**RE: Dollar General Store
Preliminary Plan Review for Dollar General
Eagle, Wisconsin**

Engineering Review Memo by Lynch and Associates; dated August 4th, 2020

FINAL ENGINEERING PLANS

C7.1

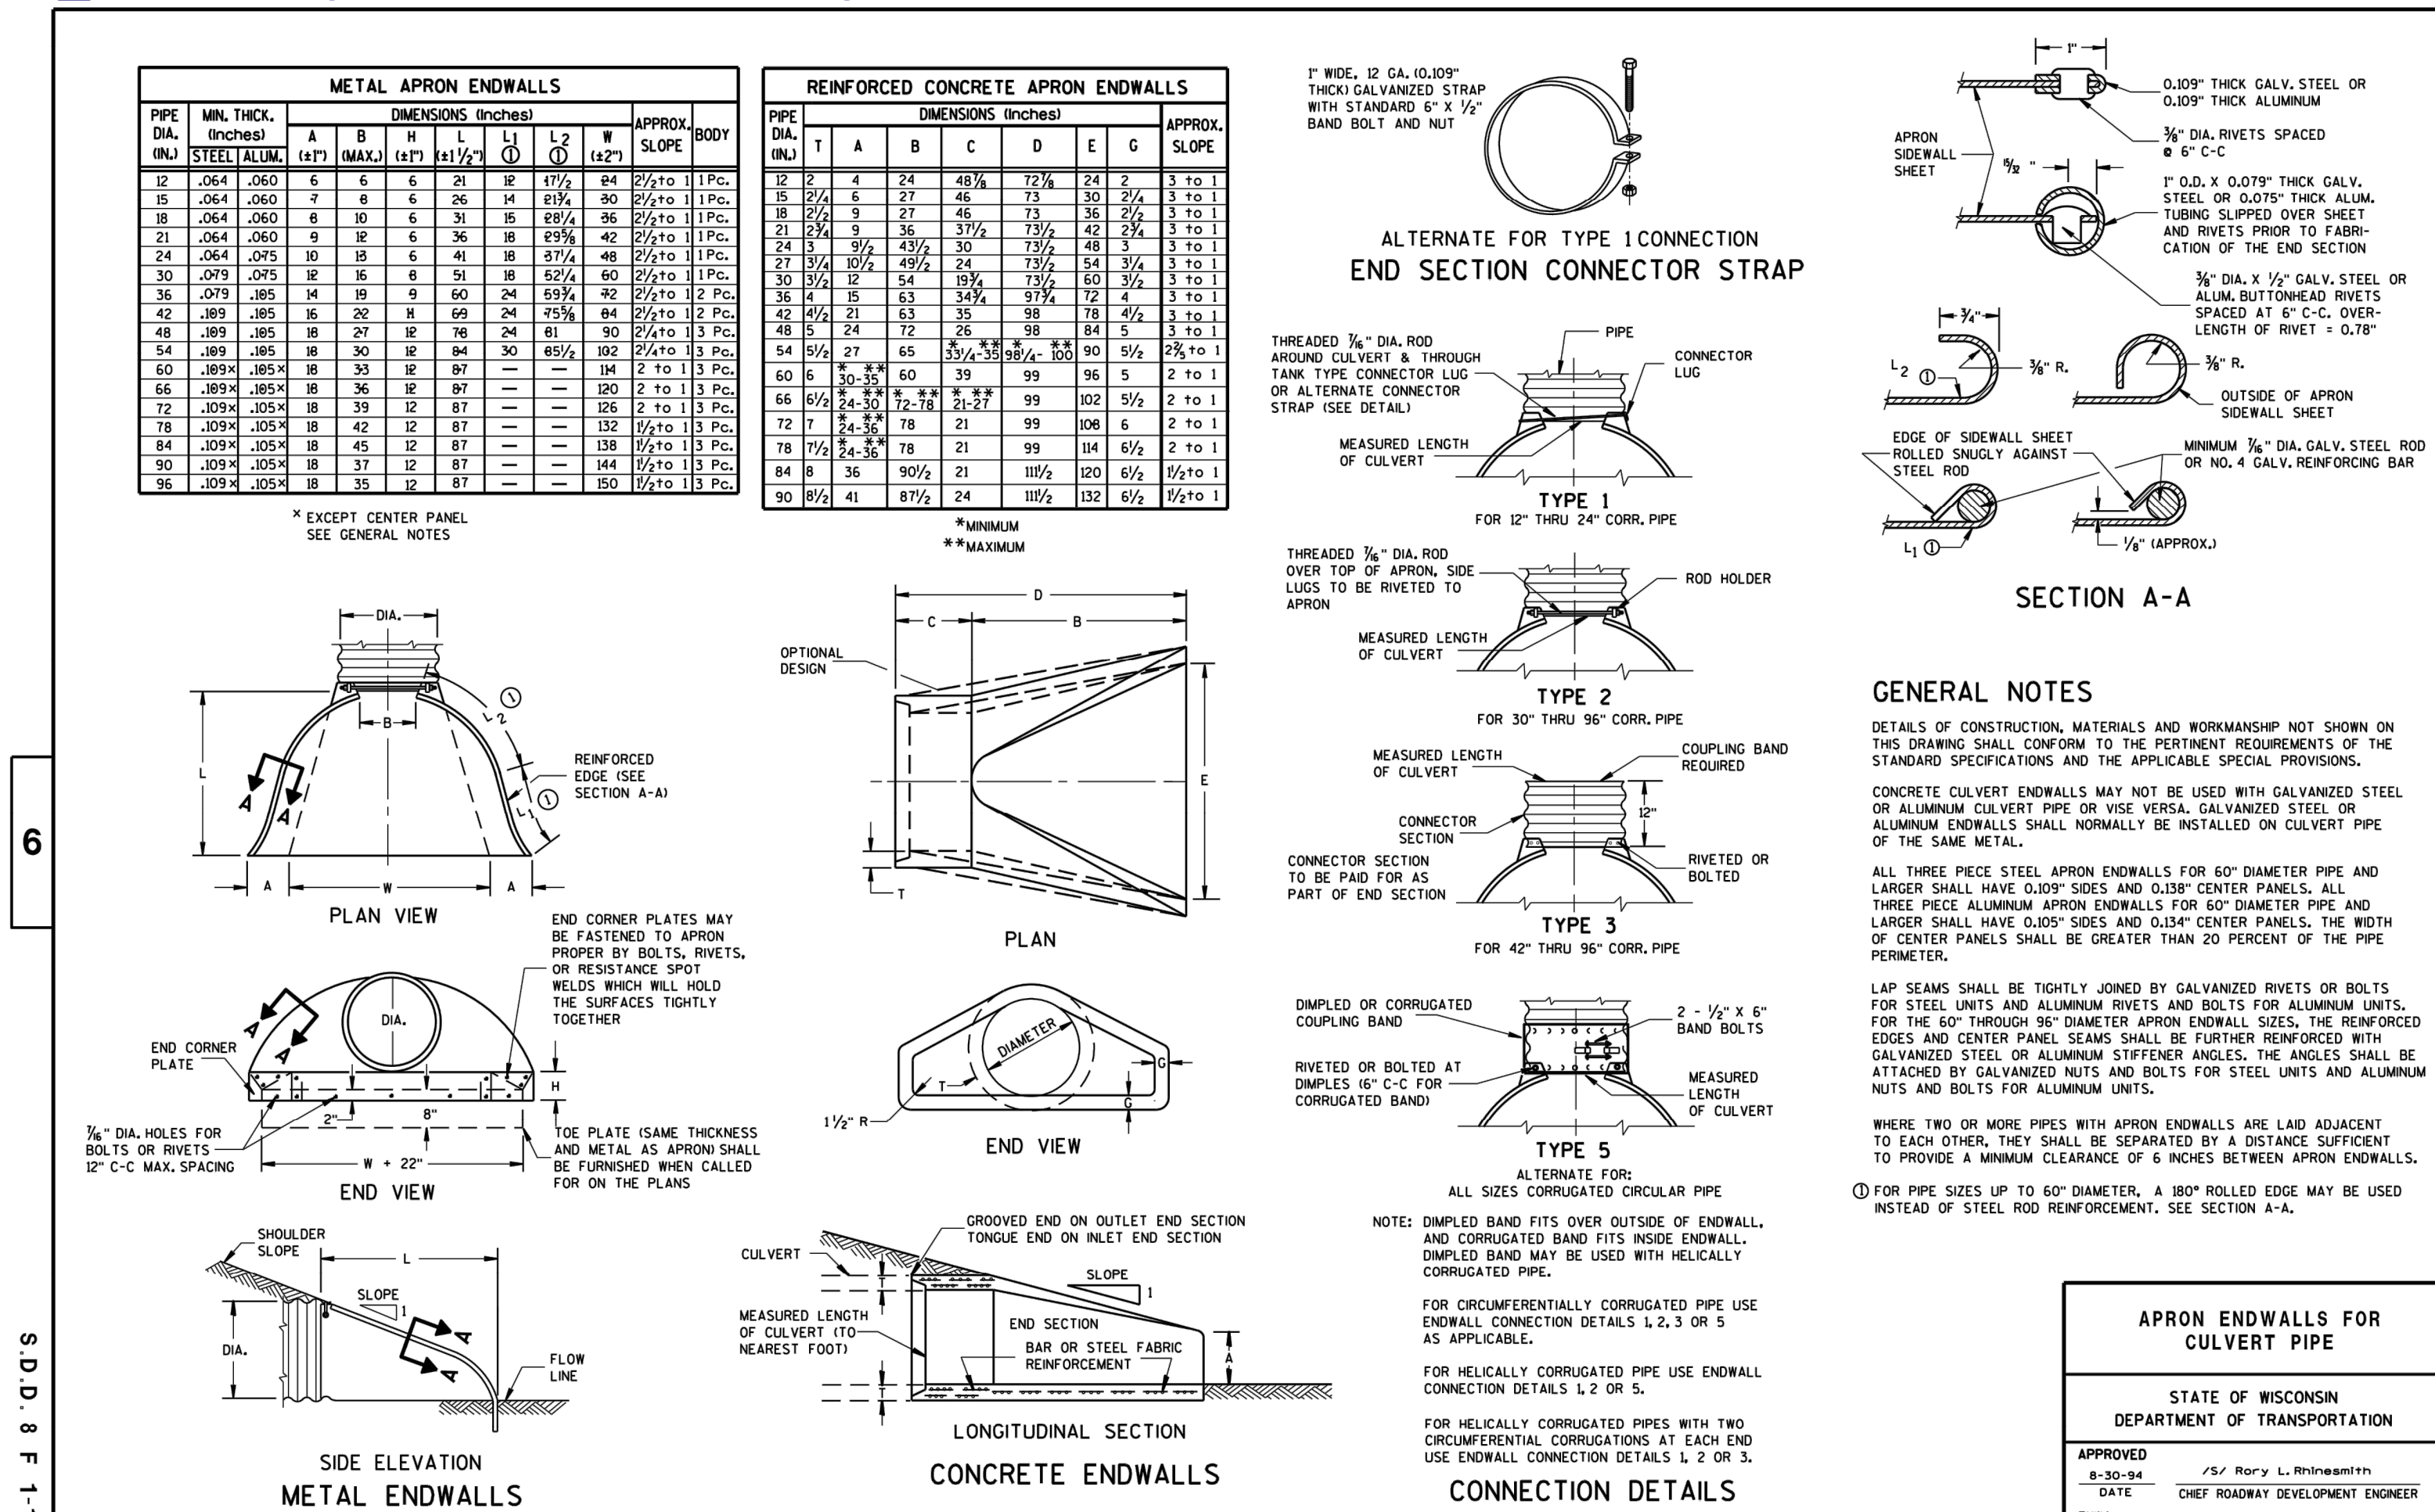
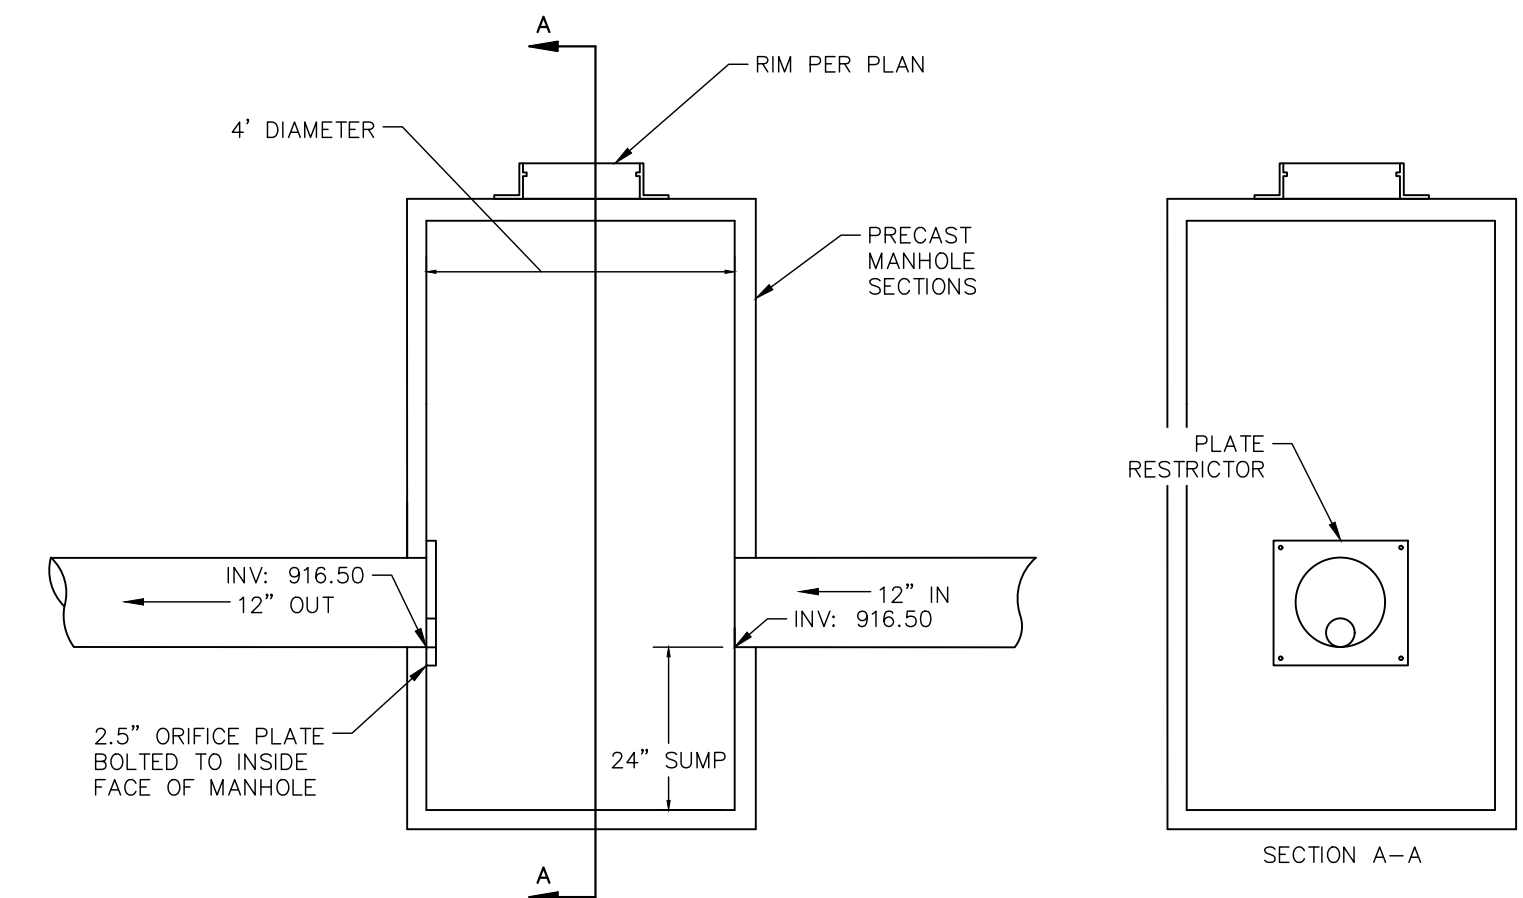
16. Provide details for the pond outlet structure, manholes, inlets and rip rap.
Response: Construction details for utility structures and rip rap have been provided on sheet C7.0 and C7.1 of the Final Engineering Plans
